# TOWN OF LAKEVILLE MEETING POSTING & AGENDA

Name of Board or Committee:	BOARD OF HEALTH
Date & Time of Meeting:	Wednesday, June 21, 2023 @ 6:00p.m.
Location of Meeting:	Lakeville Police Station 323 Bedford Street, Lakeville, MA
Clerk/Board Member posting notice:	Fran Lawrence

**A SEPTIC SYSTEM REPAIR  
IN LAKEVILLE, MA  
FOR WILLIAM & SABINE GODDEN**

Re: 24 Beechwood Avenue, 42-21-11.

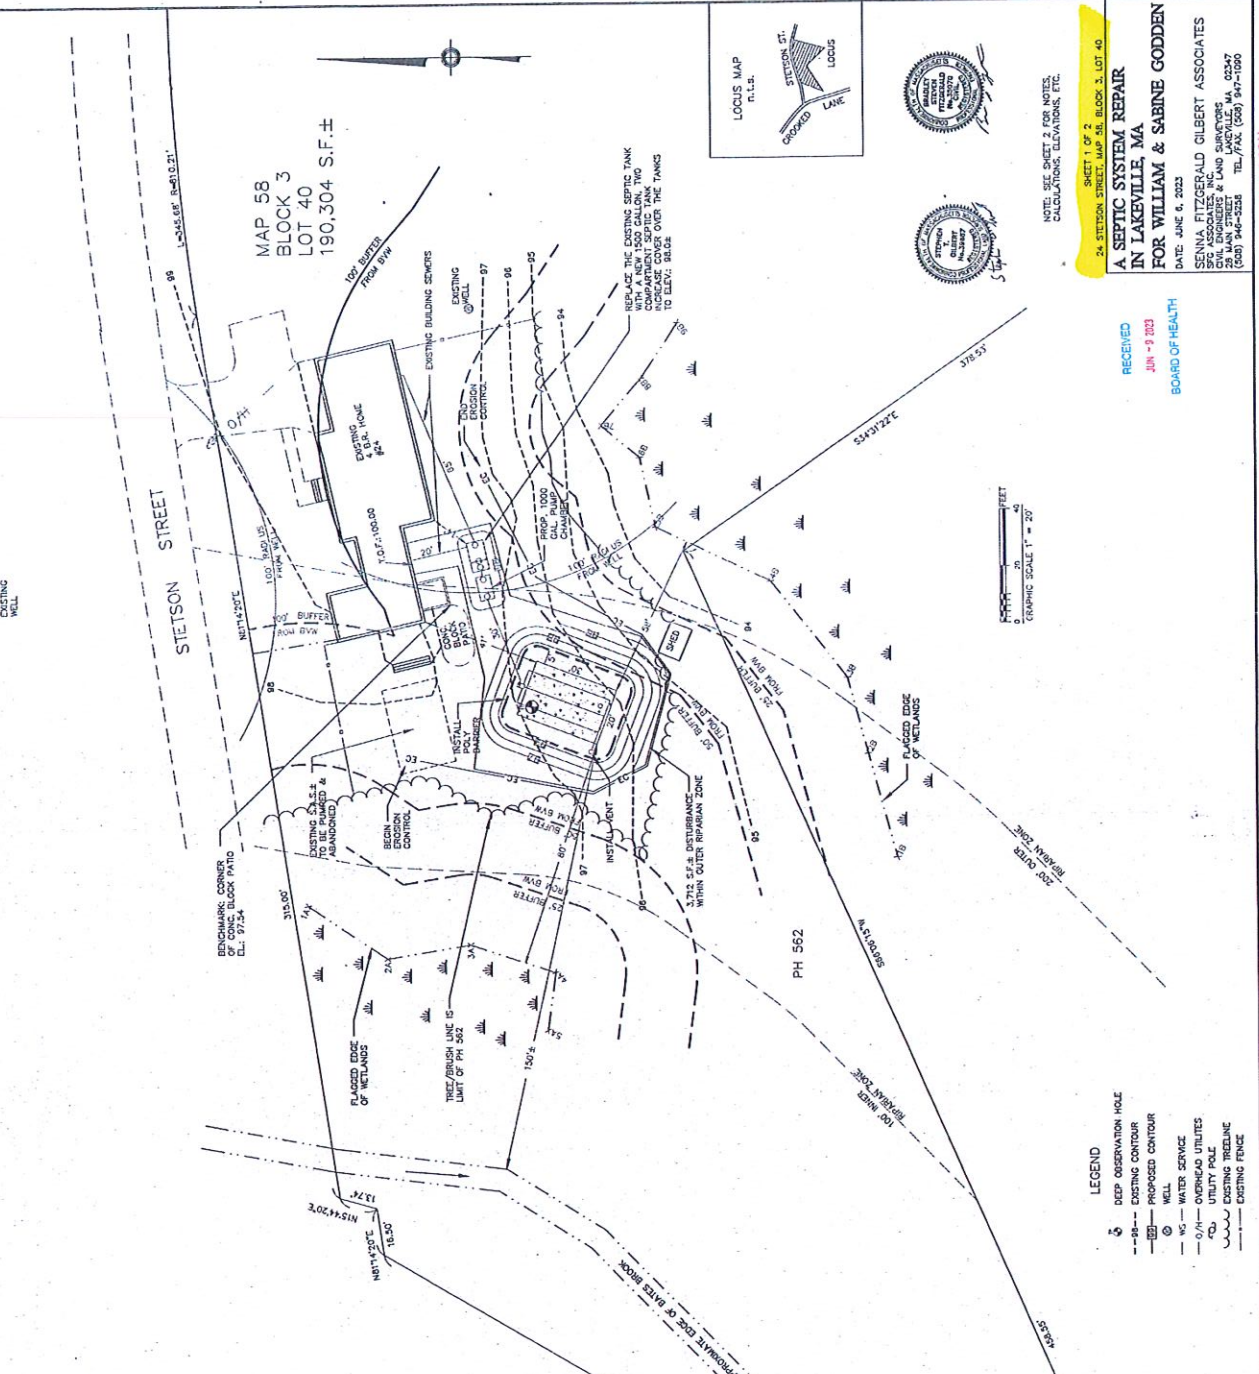
As part of the filing, the following Local Upgrades are requested under Title 5, Section 15.405(1):

- (e) to allow the soil absorption system to be approximately 80' from bordering vegetated wetlands that border a tributary (Bates Brook) to a surface water supply (Assawompset Pond), instead of the required 100'.
- (f) to allow the soil absorption system to be approximately 150' from a tributary (Bates Brook) to a surface water supply (Assawompset Pond), instead of the required 200'.
- (k) To allow for one deep hole, instead of the required two.
